# THE COUNTY OF CHESTER

## PLANNING COMMISSION

October 18, 2019

Re: Conditional Use – The Robinson Tract  
# Westtown Township - CU-09-19-16071

Figure 2: Site Plan Detail, Sheet 12, Conditional Use Application, The Robinson Tract

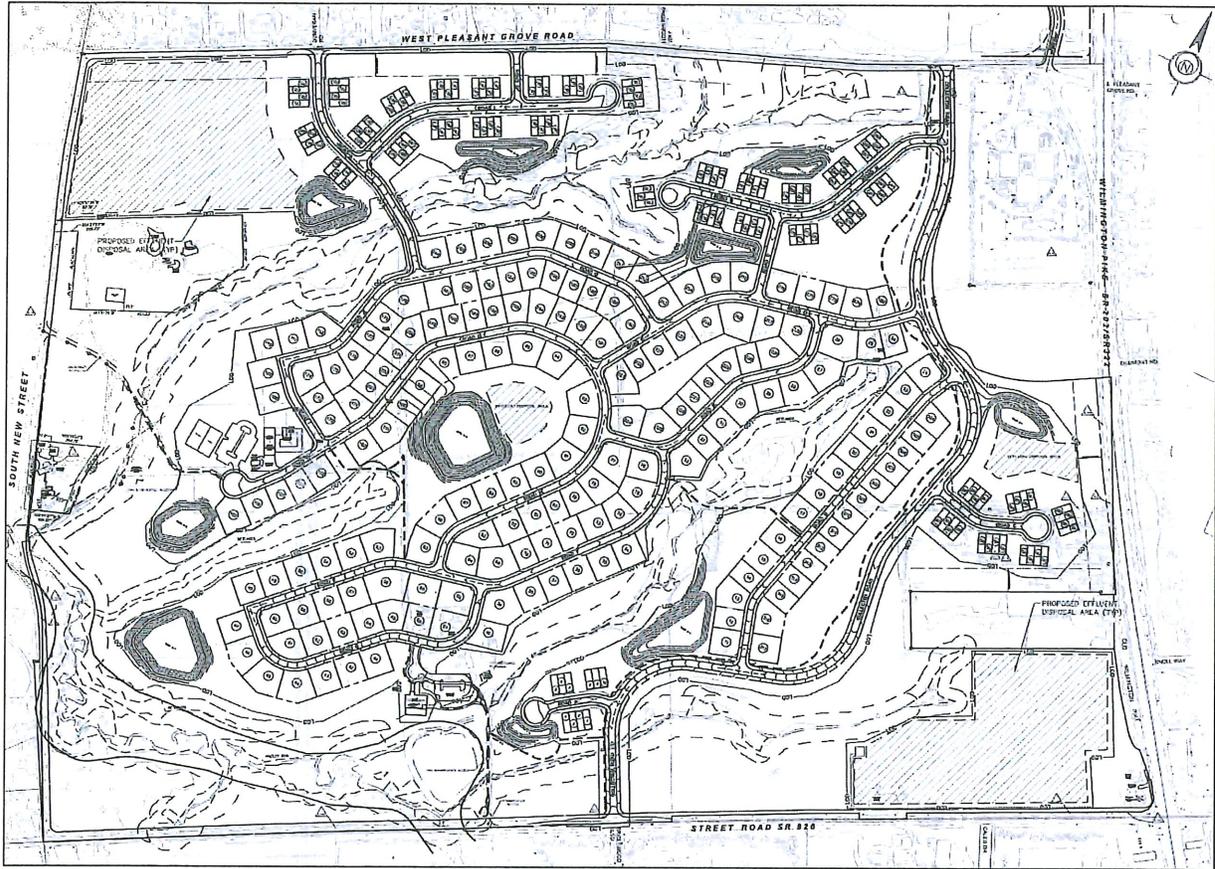
24. While Sheet 12-Overall Lot Layout provides a brief list of the tract area, proposed density and proposed impervious coverage of the development, it does not provide a zoning compliance table. This should be clarified by the applicant.

*Figure 4: Chester County Planning Commission's conceptual illustration of development on the Robinson Tract (December 7, 2016)*

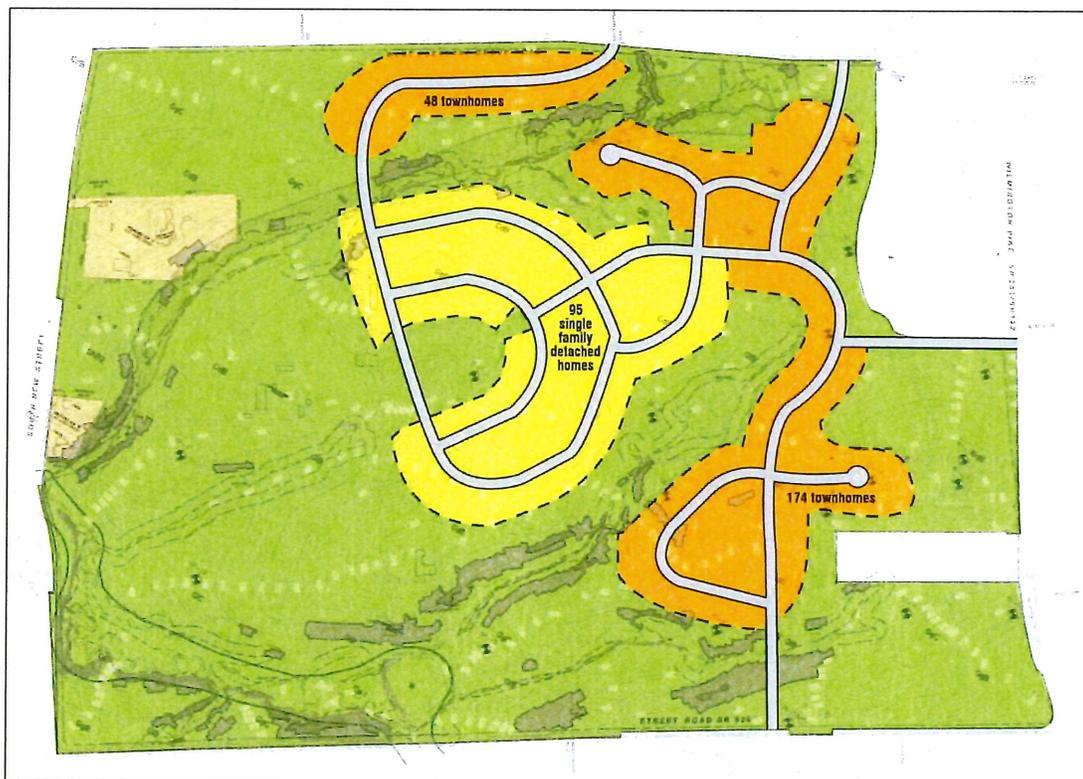
Figure 4, which was also provided in our previous review letter, provides a conceptual illustration of how development activity on the Robinson Tract can be located outside of the majority of the Rural Landscape and Brandywine Battlefield area. The County Planning Commission would be happy to work with the applicant and the Township on alternative sketch plans of the site that have a higher proportion of townhouses, along with more open space provided on the portion of the tract located in the Rural Landscape.
